DATE: March 13, 2026
TO: ALL CONTRACTORS
FROM: DUSTIN TILL
PROJECT: ROSCOE ROAD WATER TREATMENT PLANT
ORANGE BEACH WATER AUTHORITY
GMC PROJECT NO. CMOB230049
RE: ADDENDUM #5

ADDENDUM NUMBER 5

ROSCOE ROAD WATER TREATMENT PLANT

GMC PROJECT NO. CMOB230049

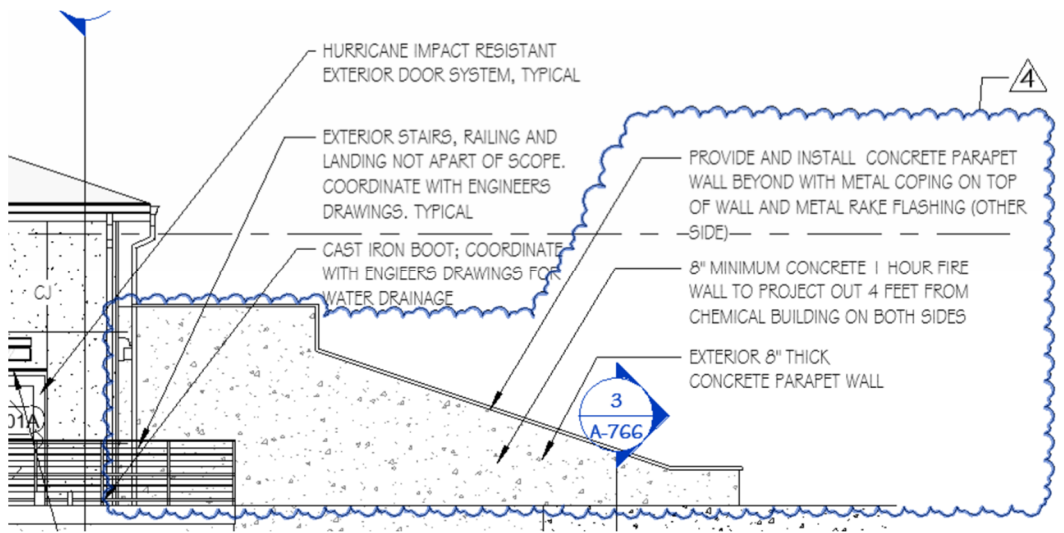
Answer: The contractor should plan to provide their own temporary power.
- 5.31 **Question: Spec section 46 41 17 Inline Static Mixers paragraph 2.1.B.1.a calls out the mixer MXR5010 to be 16" Ø. Plan Sheet D-881 Shows the mixer on a 24" line. Just want to confirm it is 24"Ø.**

Answer: Yes, the mixer is 24".

EXTERIOR ELEVATIONS

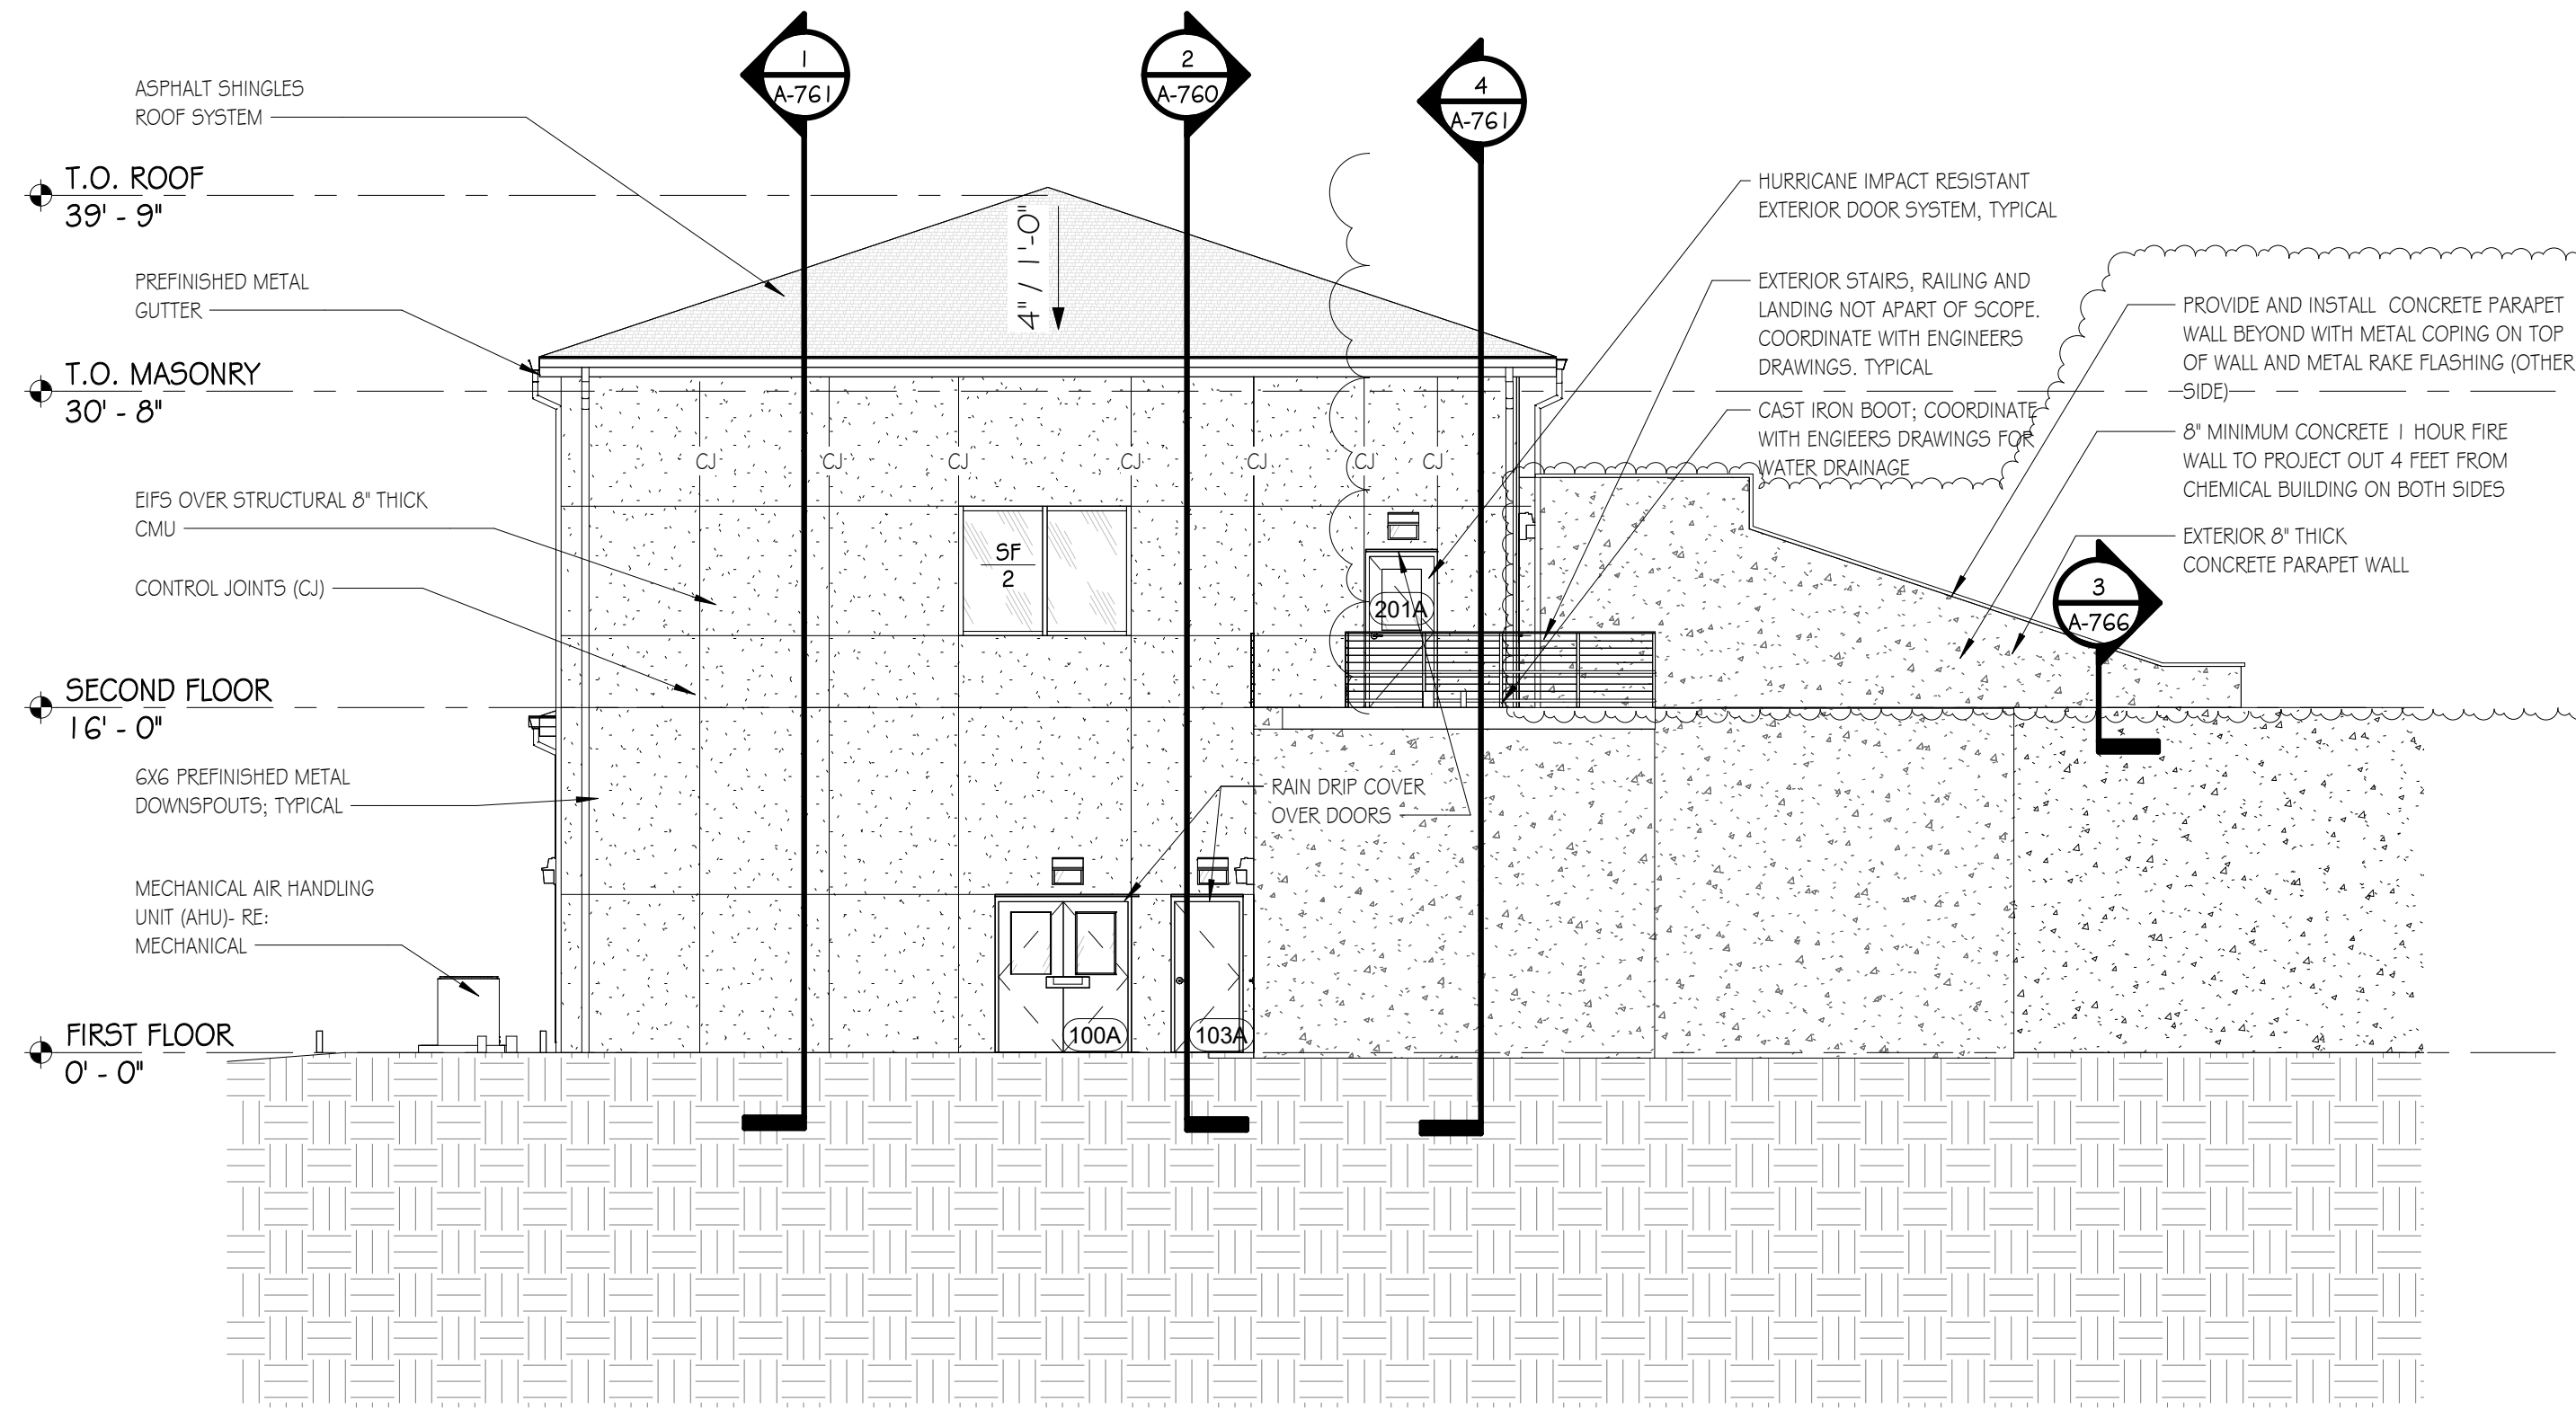
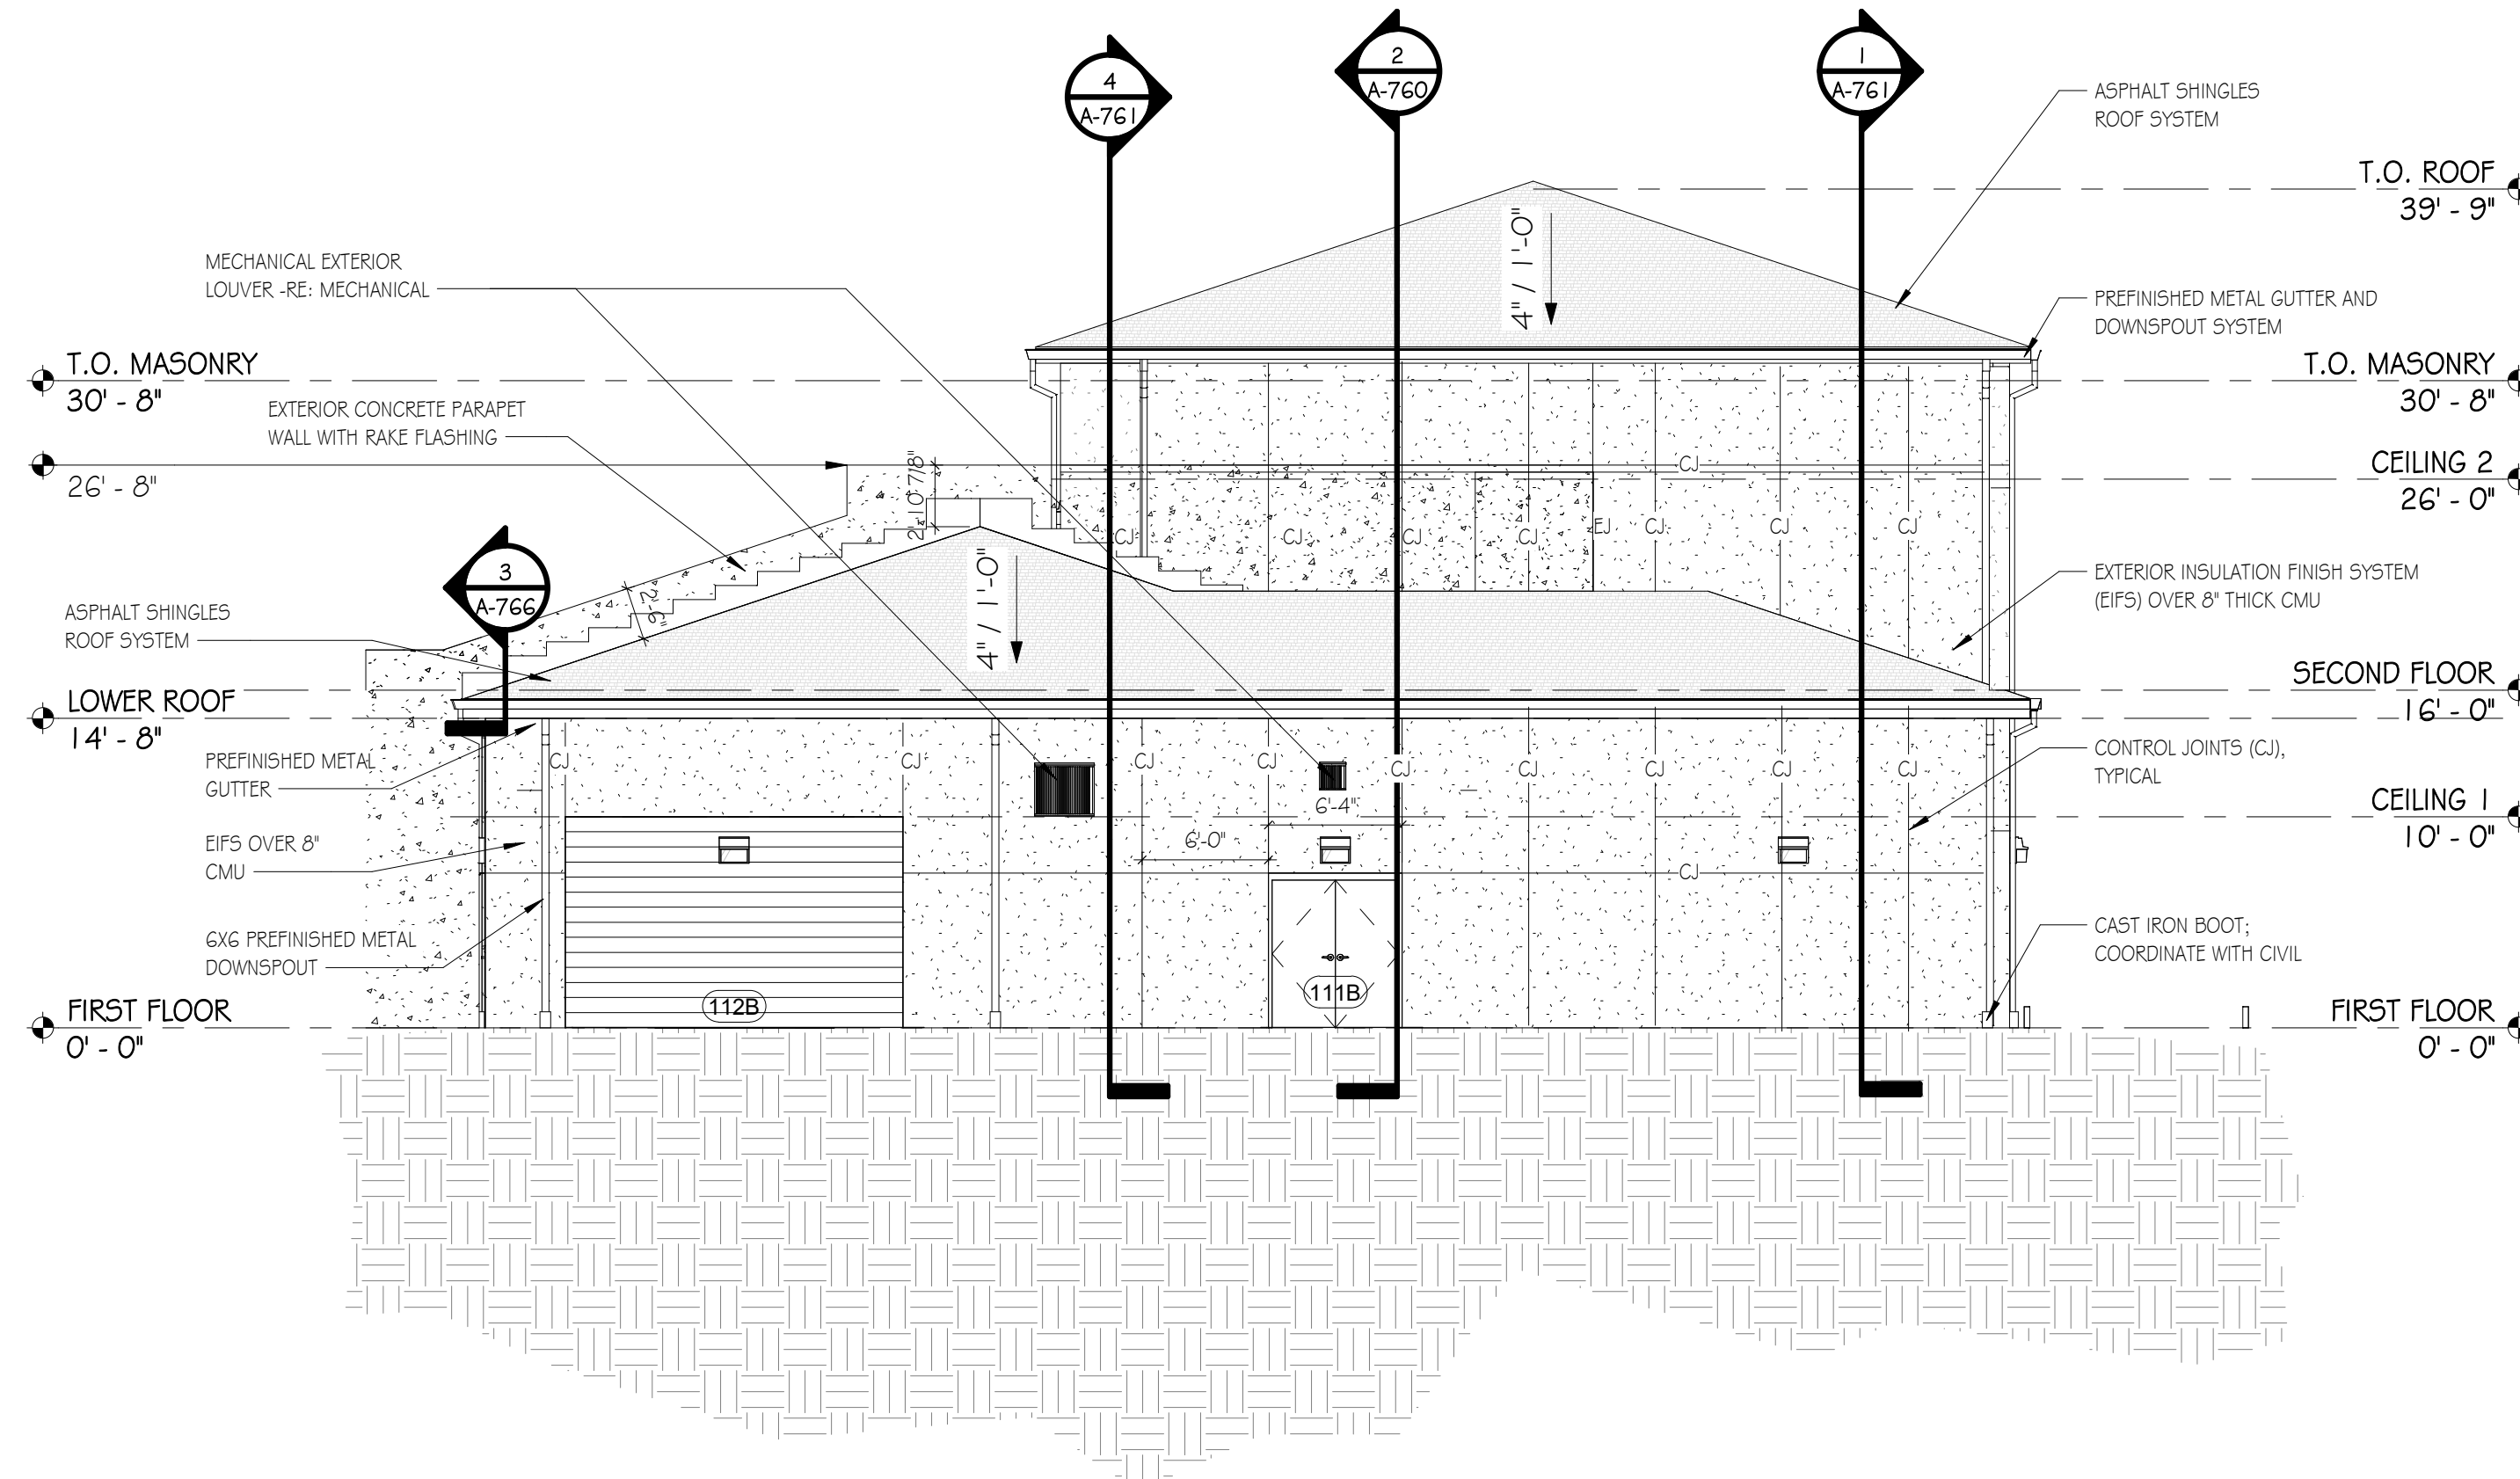
5.43 **Question: Referencing Sheet A-752, the parapet wall above the chemical building is shown with two different designs in each view on A-752. The West view shows a full height wall all the way across. The East view shows a wall that is tapered down. Please confirm which view is the correct design for this wall.**

Answer: The wall should be tapered down as shown below.
